Access Compliance Report

Public Rights-of-Way

Intersection ID: 9508	Main Street: DUNSTAN_CT	Cross Street: VICKERY_DR	Location: SE
ADA ID: 25BB7B739774	Ramp Type: BlendTrans1	Initial Pass/Fail: Pass	Overall Compliance: No
Codes/Mitigation Info/Possible Solution		Field Measurements/Component Compliance	
Severity Score: 7.5

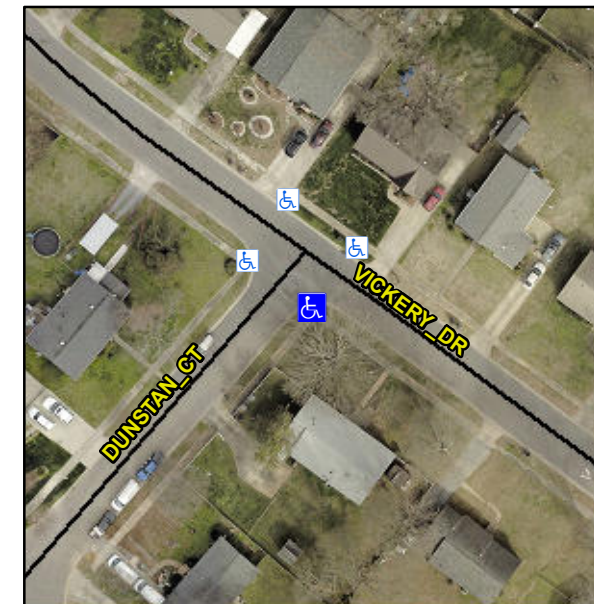
Not Found, R304.2.1, R305.2, R302.7, R302.7.2

Remove & Replace Curb Ramp With Two New Directional Ramps or Equivalent.
